Docket Item #18
BAR CASE #2004-0237

BAR Meeting
November 3, 2004

ISSUE: Conceptual Review of New Townhouses and Garages

LOCATION: 711-717 Gibbon Street

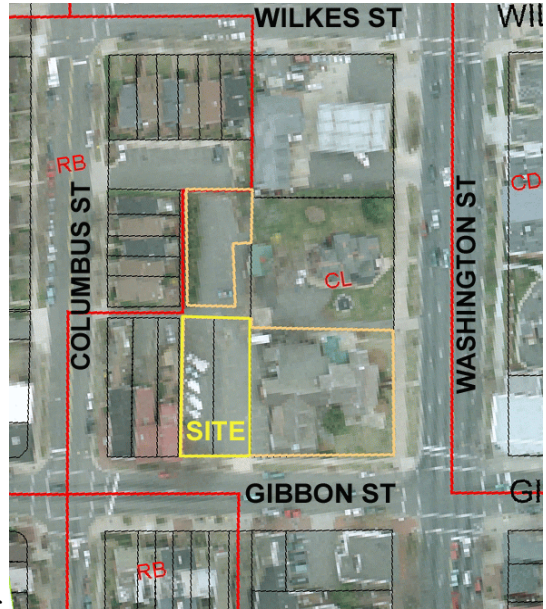
There are a pair of Georgian Revival style townhouses flanked by a pair of Federal Revival style townhouses on the eastern and western facade. While the styles are characteristic of buildings found within the district, staff is concerned about the “symmetrical” nature of the design as discussed in more detail below. The townhouses are each two and a half stories in height. All are clad in brick and have standing seam metal roofs and brick stoops. The center pair are each two bays wide with a pedimented doorway, with a six panel door and a six-over-six true divided light wood window on the first level; there are two six-over-six true divided light wood windows on the second level. The windows have brick sills and painted brick jacks arches. The windows on this pair of houses have panel shutters. Each house also has a pedimented dormer.

The proposed composition of two matching colonial style townhouses in the center of the street face, bracketed by an alternately-designed matching colonial style townhouses on the east and west end, presents an a pattern of townhouse construction that is

atypical within the district. Historically, townhouses were built in groupings of two or three (or more) which has resulted in a grouping of styles that create the rich fabric of the district today. Therefore, staff recommends that similarly styled townhouses be grouped together in pairs, as generally depicted in the graphic below, rather than arranged in a symmetrical grouping with flanking townhouses, which is not characteristic of the district. Staff believes that with this simple grouping of townhouse with the more modest scale units adjacent to the existing Old Club building, the proposal will be more consistent with the character of the historic district. Staff believes the grouping of styles is one of the characteristics that adds to the variety, richness and texture of the district and is character defining element of the district.

1. The units are grouped in pairs as generally depicted in *Attachment # 1*.
2. The detached townhouse garages and condominium garages provide a more varied roofline.
3. The detached townhouse garages and condominium garages provide more variation in materials and detailing.
4. The units shall be entire masonry (brick, stone or precast).
5. The roof material shall be metal or faux slate.
6. The windows shall be true divided light windows.

Site Plan showing Old Club, townhouses with private garages, and condominium garages

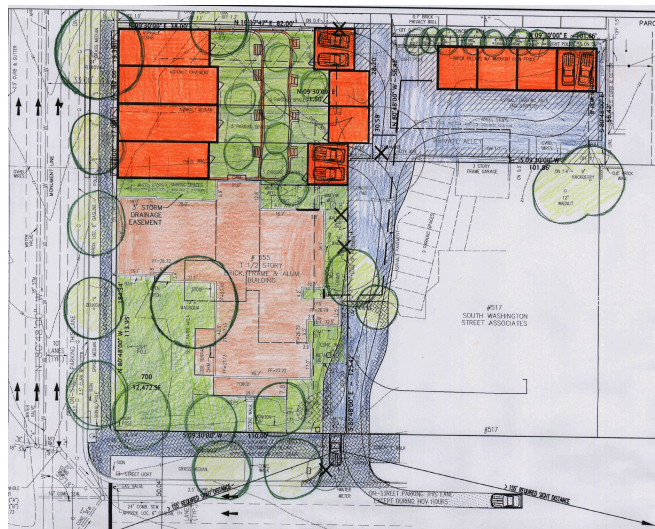
Staff strongly supports the use of detached garages, which are typical of most blocks within the district. However, a concern is that the garages are designed to appear as one monolithic structure rather than the small independent outbuildings characteristic of the district. Therefore staff is recommending that additional variation in materials be provided between the garages and a more varied roofline for be provided for both the townhouse and condominium garages. Otherwise, staff has no objection to the garages for these townhouses.
